Administrative Manual - Team UPDATE - 2013-03-26	4
Administrative Manual - Team UPDATE - 2013-03-26	5
Administrative Manual - Team UPDATE - 2013-02-22	7
Administrative Manual - Team UPDATE - 2013-02-22	8
Administrative Manual - Team UPDATE - 2013-02-19	9
Administrative Manual - Team UPDATE - 2013-02-19	10
Administrative Manual - Team UPDATE - 2013-02-19	11
Administrative Manual - Team UPDATE - 2013-02-19	12
Administrative Manual - Team UPDATE - 2013-02-15	13
Administrative Manual - Team UPDATE - 2013-01-29	14
Administrative Manual - Team UPDATE - 2013-01-25	15
Game Manual - Team UPDATE - 2013-04-23	16
Game Manual - Team UPDATE - 2013-04-16	17
Game Manual - Team UPDATE - 2013-04-09	18
Game Manual - Team UPDATE - 2013-04-09	19
Game Manual - Team UPDATE - 2013-04-02	20
Game Manual - Team UPDATE - 2013-04-02	21
Game Manual - Team UPDATE - 2013-03-19	22
Game Manual - Team UPDATE - 2013-03-12	23
Game Manual - Team UPDATE - 2013-03-05	24

# Game Manual - Team UPDATE - 2013-04-23

Figure 2-7: The PYRAMIDS

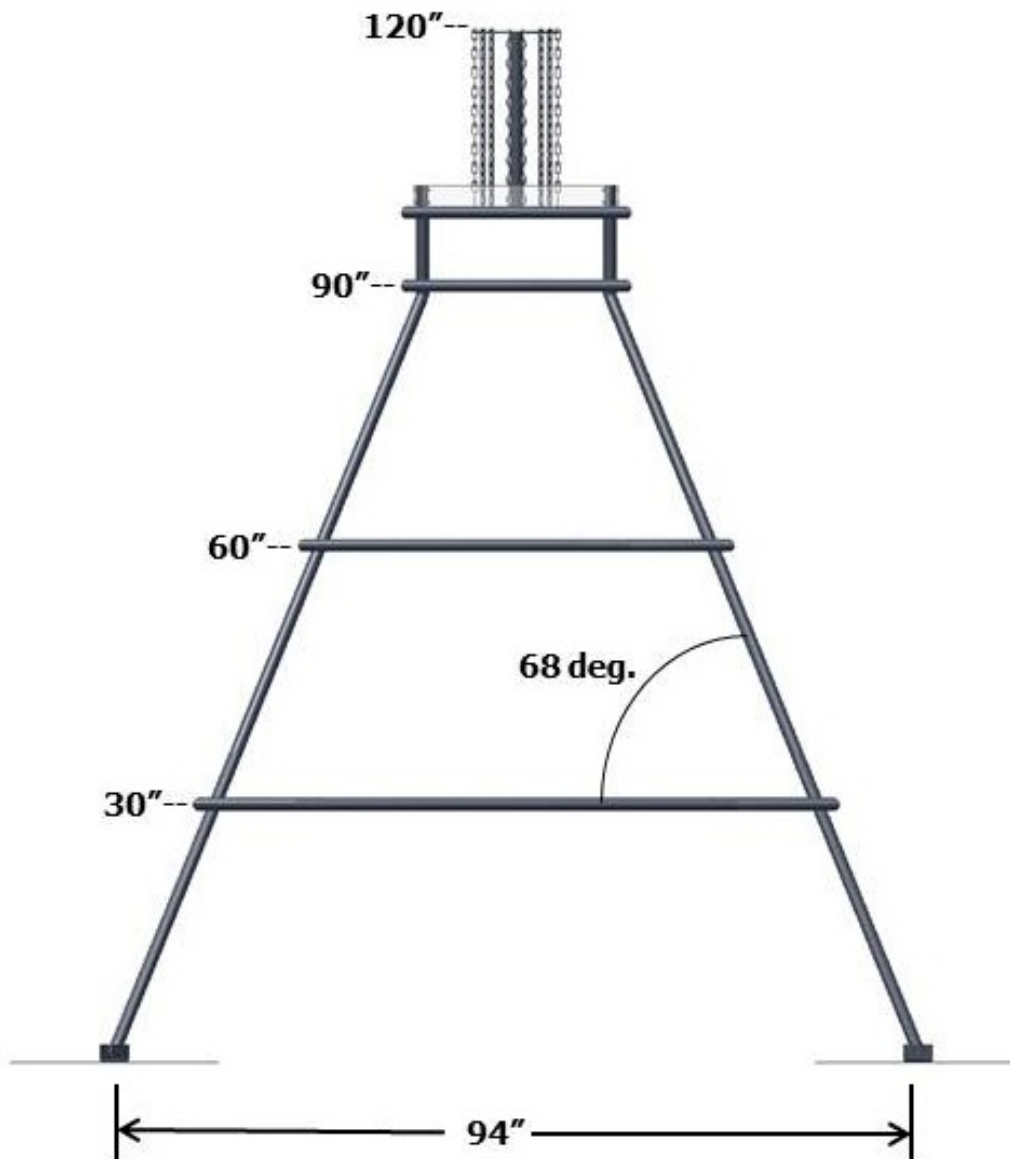
An ALLIANCE specific PYRAMID is located in each half of the FIELD. The PYRAMID is made out of 1 1/2 in. diameter steel tubing and powder coated Red or Blue. It is 94 in. wide at the base and each side slanted at a 68-degree slope. The rungs are located 30 in., 60 in., and 90 in. off of the floor. At the top of the PYRAMID is the PYRAMID GOAL, detailed in Section 2.2.4 The GOALS.

The PYRAMID has four (4), 24 in. square, 11 GA. (.120 in.) steel bases with hook and loop tape (“hook” side) on the bottom. These bases secure the PYRAMIDS to the carpet. To prevent damage to venue

Figure 2-9: ROBOT Using Belay Device (UPDATED)

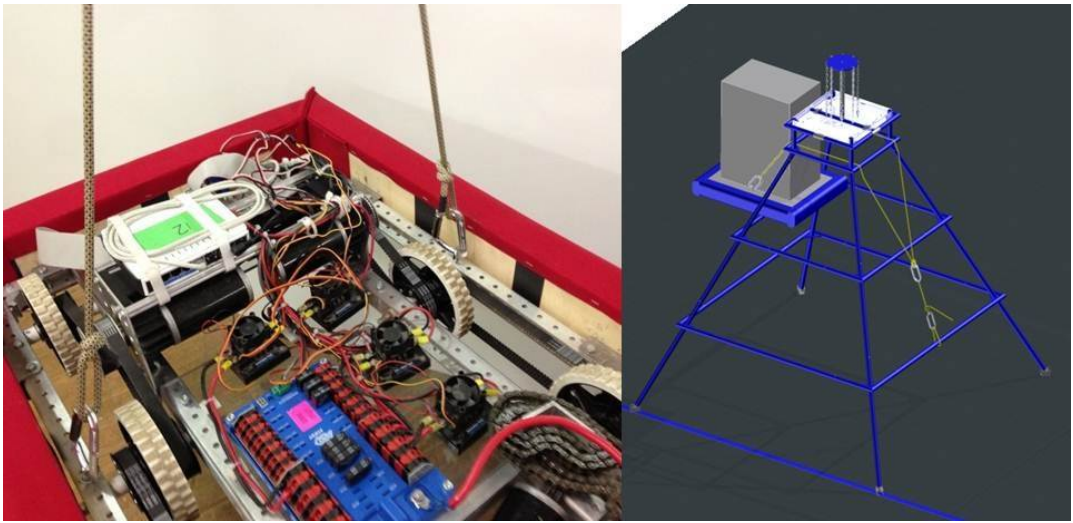
Teams may have to remove their ROBOT from the PYRAMID after the MATCH is over with the aid of a *FIRST* supplied belay system, per [G04](#). The belaying device acts as a brake to prevent accidentally dropped ROBOTS from causing injuries to teams. The device attaches to the ROBOTS with two carabiners or loops of rope. Teams must supply two attachment points for the belaying device to mount to their ROBOTS, per R10. The belaying rope is fed through a brake that is anchored to the lowest rung on the opposite side of the PYRAMID from the ROBOT. It is then fed through the PYRAMID top and down the other side to be attached to the ROBOT. There is a "bridle" that splits the rope into two sections, which are 90 in. long.

Only trained event staff are allowed to use the belaying device.

Figure 3-5b: Offset Plane from PYRAMID Base

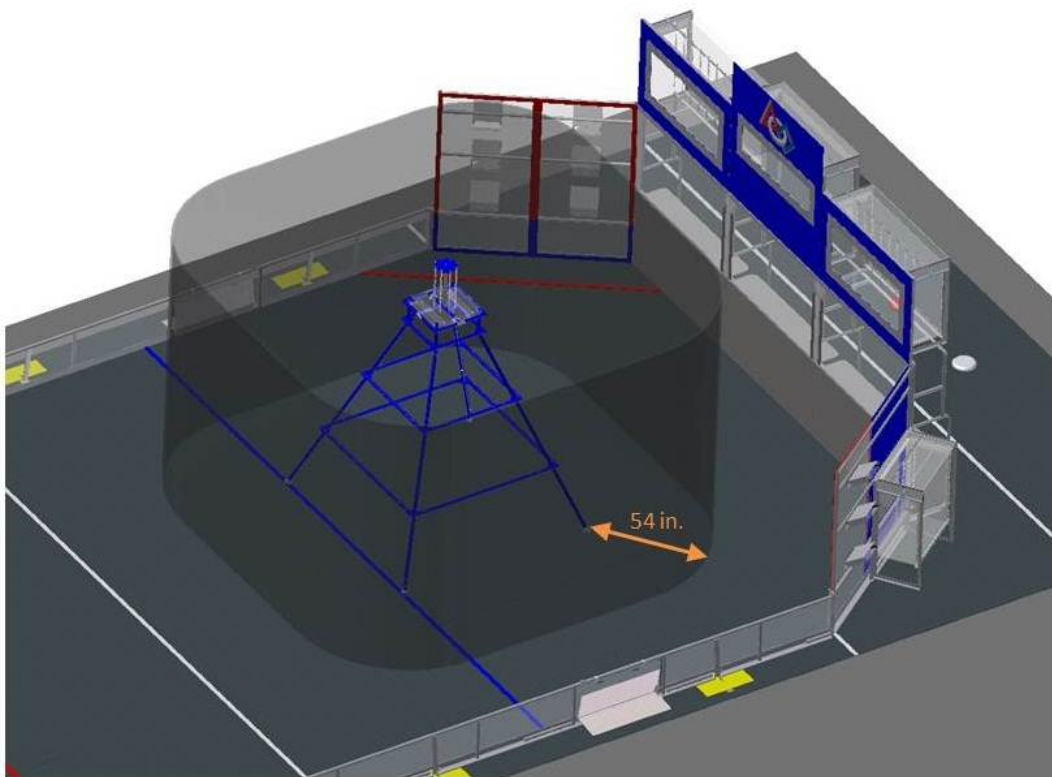
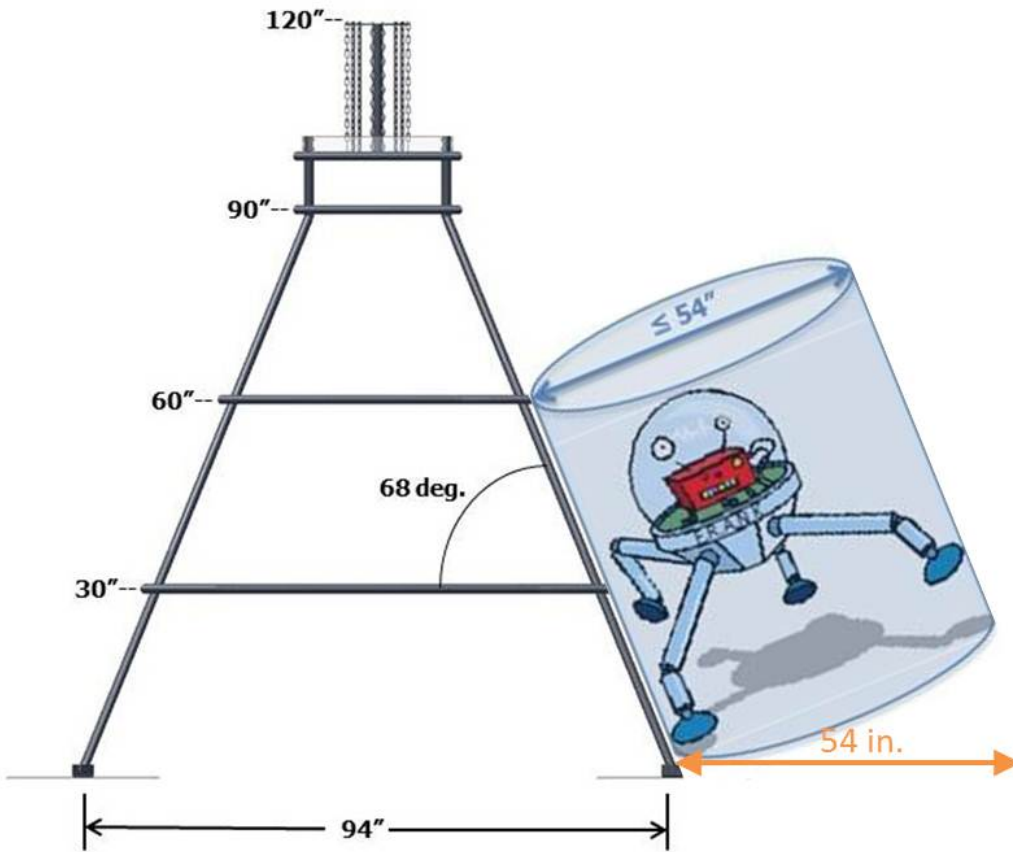
- A. may not have its horizontal dimensions exceed a 54 in. diameter vertical cylinder relative to the ROBOT and
- B. may not extend any part of itself beyond a vertical plane defined by a perimeter offset from the base of the PYRAMID by 54 in., see Figure 3-5b and Figure 3-5c.

Figure 4-1: FRAME PERIMETER Length Calculations

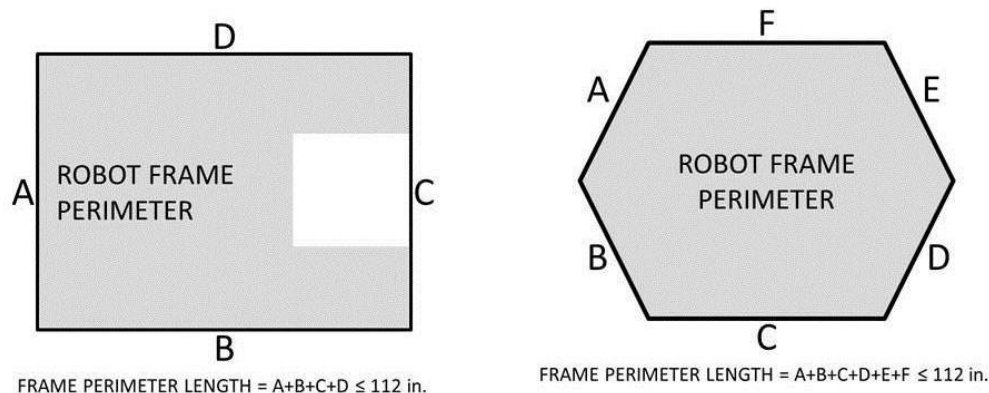
- A. total length of the FRAME PERIMETER sides may not exceed 112 in. (see [Figure 4-1](#) for examples),
- B. PLAYING CONFIGURATION horizontal dimensions may never exceed a 54 in. diameter vertical cylinder (see [G23](#) and [G23-1](#)), and
- C. height may never exceed 84 in. tall.

Figure 4-2: BUMPER Corner Examples (UPDATED)

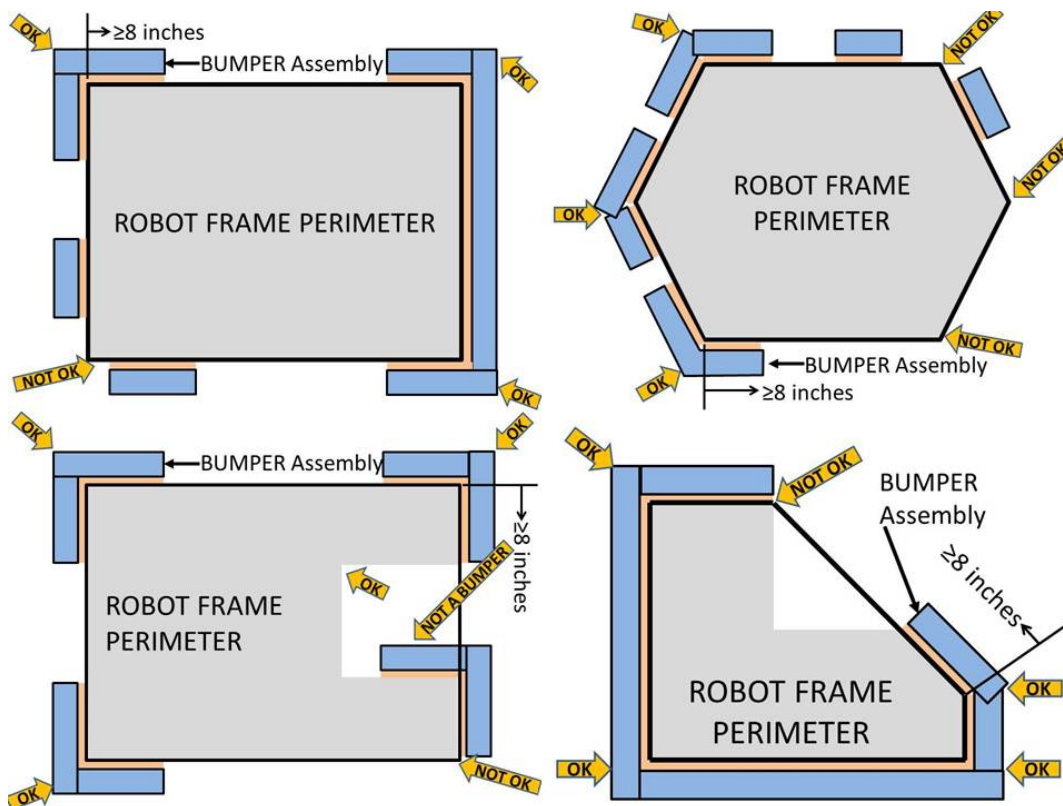
ROBOTS are required to use BUMPERS to protect all outside corners of the FRAME PERIMETER. For adequate protection, at least 8 in. of BUMPER must be placed on each side of each outside corner (see [Figure 4-2](#)).

The dimension defined in R22 is measured along the FRAME PERIMETER. The portion of the BUMPER that extends into the corner is not included in the 8 in. requirement.

Figure 2013-01-15

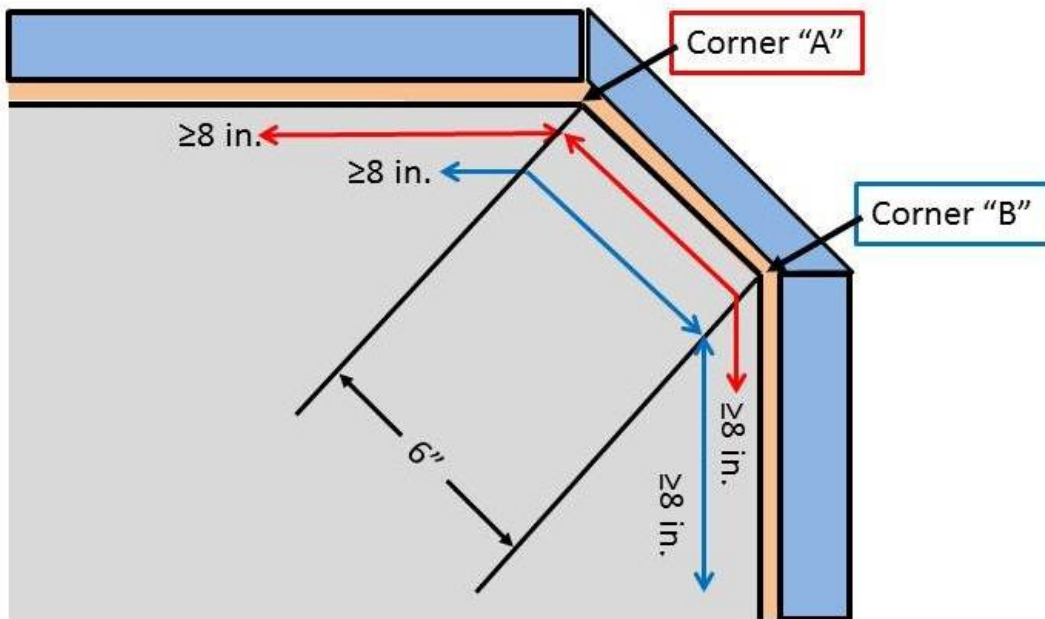
The Inspectors also asked for clarification on the 8 in. BUMPER requirement of R22. As stated in the Blue Box on R22, the dimension is measured along the FRAME PERIMETER. In Figure 2013-01-15 below, the edge of the FRAME PERIMETER between Corner A and Corner B is only 6 in. To satisfy the 8 in. requirement for Corner A, there must be at least 8 in. of BUMPER in each direction. Thus, the measurement along the 6 in. side would continue past Corner B for 2 more inches.

Figure 3-4: PYRAMID Levels

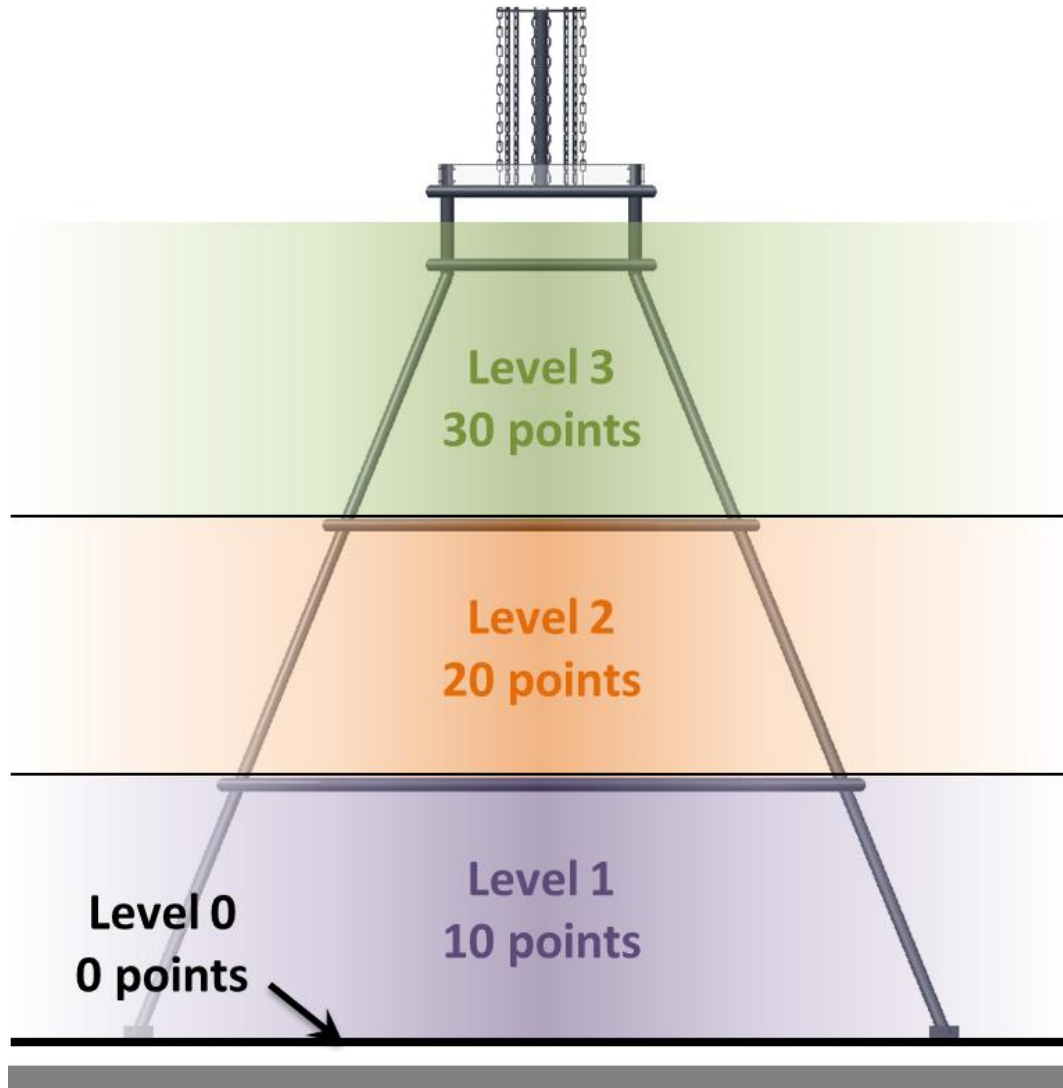
Points are awarded for the highest Level achieved for every ALLIANCE ROBOT that CLIMBS its PYRAMID. The Level to which a ROBOT has CLIMBED is determined by the lowest point of the ROBOT (in relation to the FIELD) **at the point in which final scores are assessed per [Section 3.2.4](#)**. CLIMB point values and Levels are defined in [Figure 3-4](#).

As competition at the *FIRST* Championship is typically different from that during the competition season, *FIRST* may alter the value of CLIMBING at the *FIRST* Championship by up to ten (10) points per Level.
